**CITY OF BATON ROUGE  
PARISH OF EAST BATON ROUGE  
DEPARTMENT OF ENVIRONMENTAL SERVICES**

**ADDENDUM NO. 2**

SUBJECT: **PS 299 REGIONAL PUMP STATION**

**CITY-PARISH PROJECT NO. 20-PS-IF-0109**

C-18R

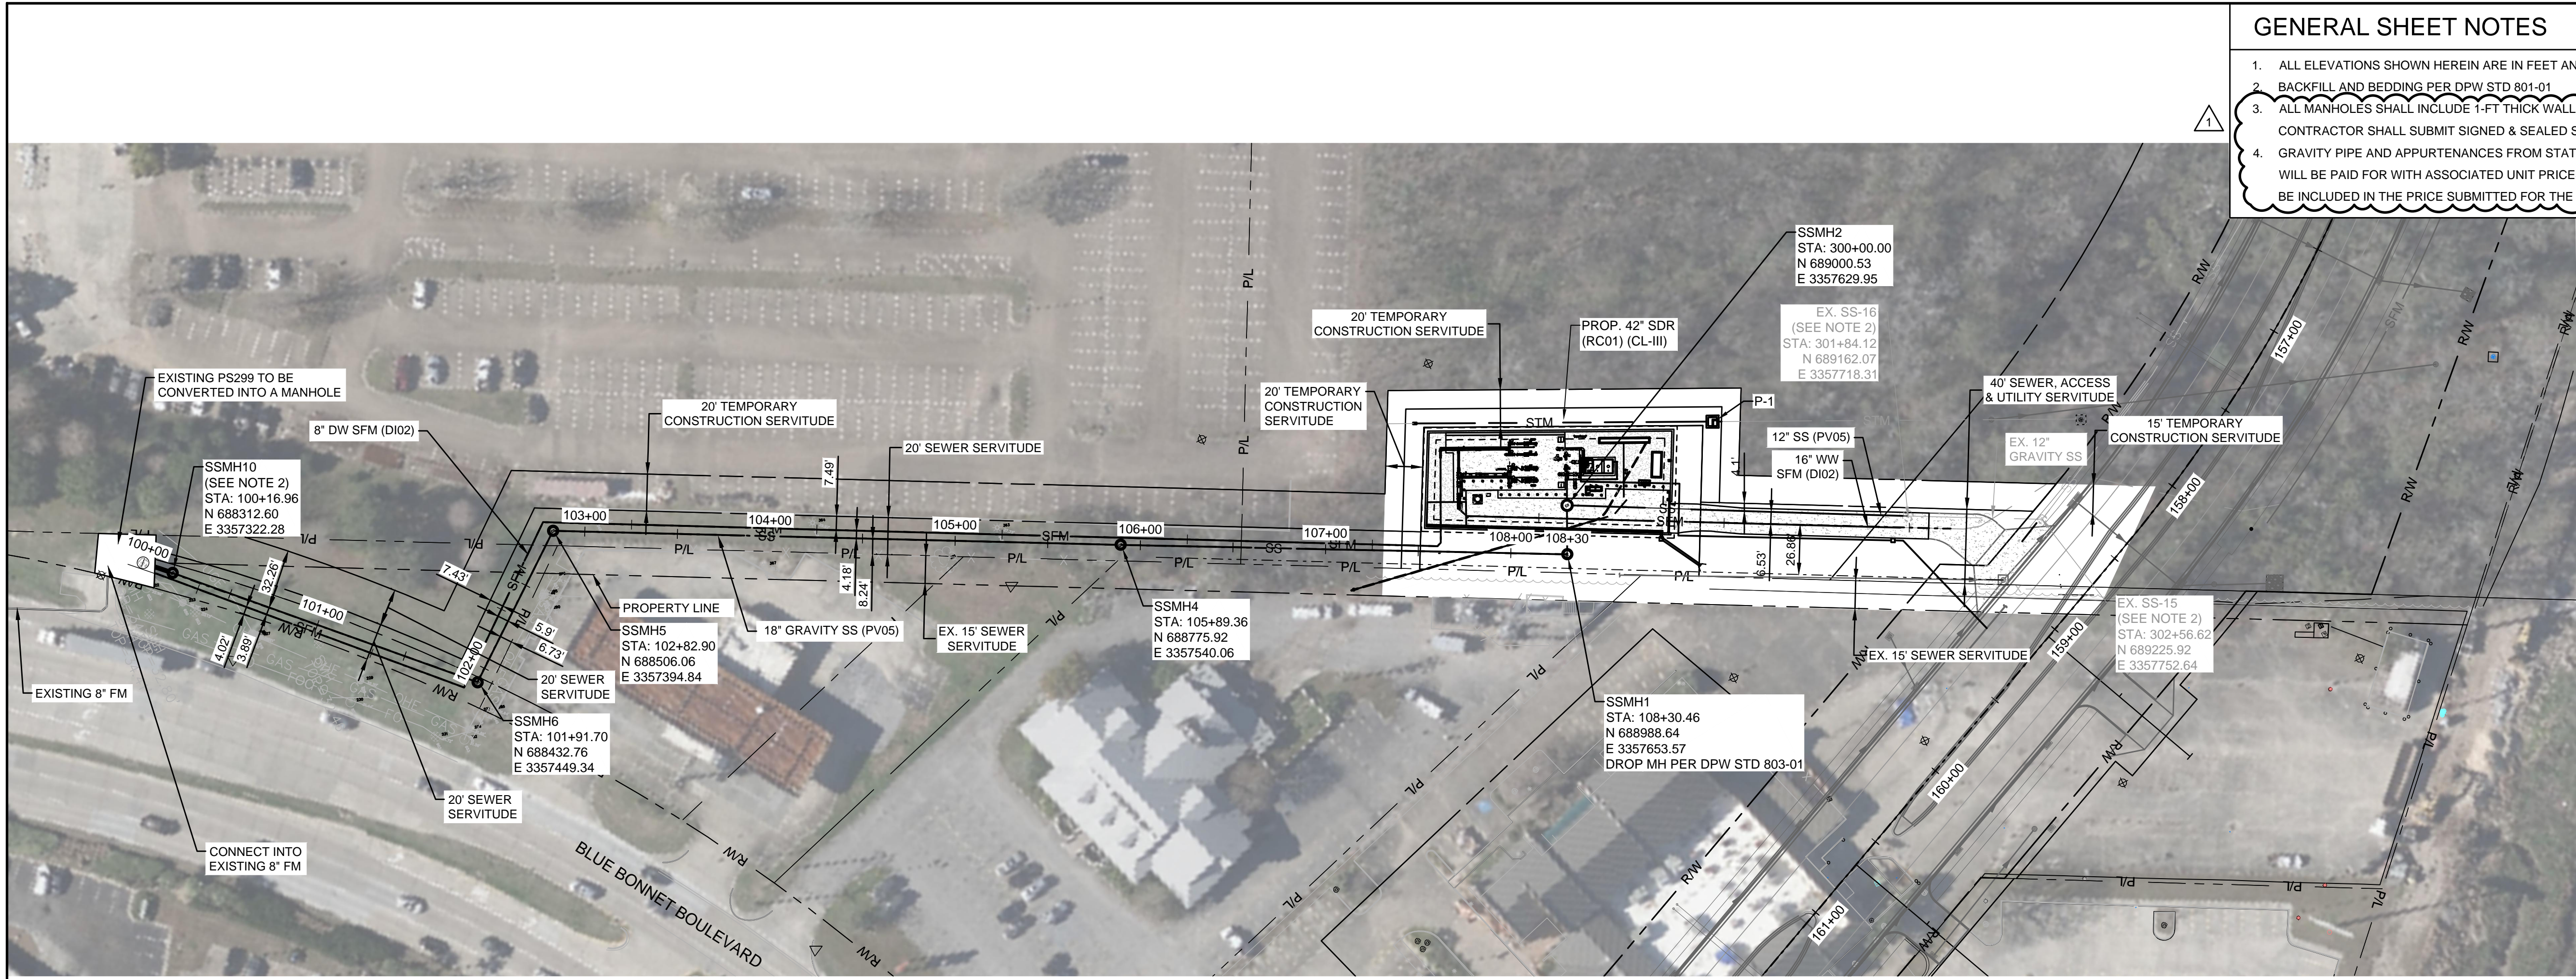
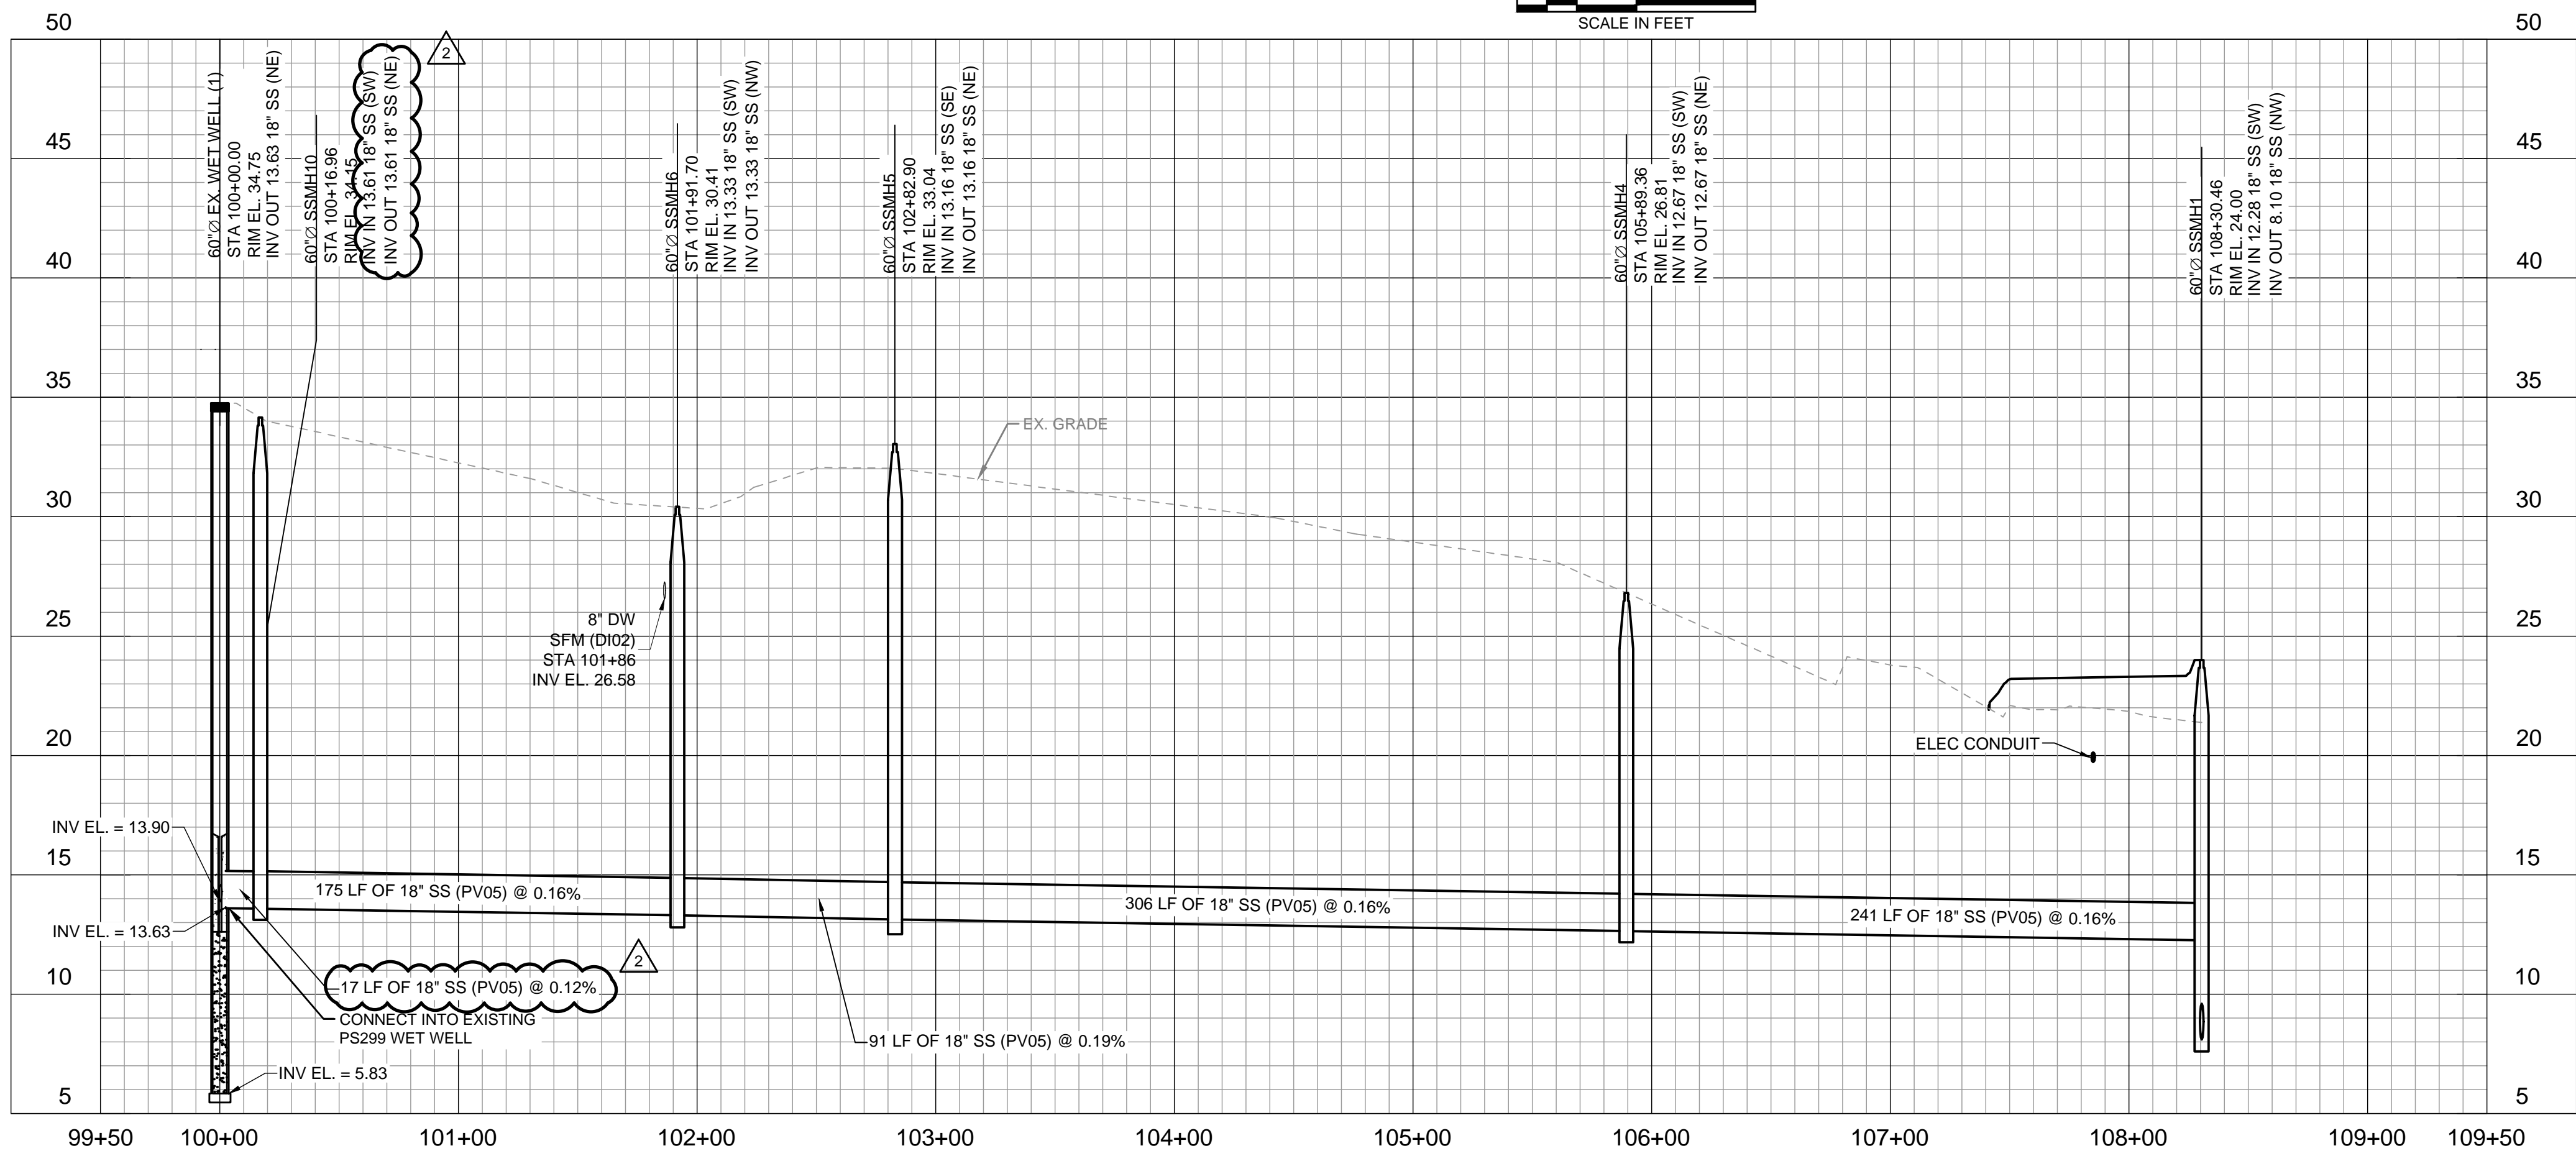
1. For paper sealed bidders, with reference to page UCBF 1 of 4 of Part 1, Uniform Construction Bid Forms, the Bidder shall indicate the receipt of this addendum in the space provided. For online Central Bidding bidders, an acknowledgement of this addendum will be prompted by the electronic bidding program prior to formally submitting the bid. **Failure to indicate the receipt of this addendum shall be cause for the bid to be rejected.**
2. DELETE Drawing C-18R and REPLACE with attached Drawing C-18R Civil Sewer Plan and Profile - I.
3. DELETE Drawing C-19R and REPLACE with attached Drawing C-19R Civil Sewer Plan and Profile - II.

1. The drawings in the addendum state all manholes shall include 1' thick walls, bottom slab, and top slabs. I am hearing from precast suppliers that this is only possible for 120" and larger diameter manholes so I do not think 1' thickness will be possible unless they are rectangular structures. General wall thickness for 60" manholes is 6" and 7" for 72" manholes.

The Contractor may deviate from the specified thicknesses, but are required to provide signed structural calculations, including buoyancy calculations as required by the note.
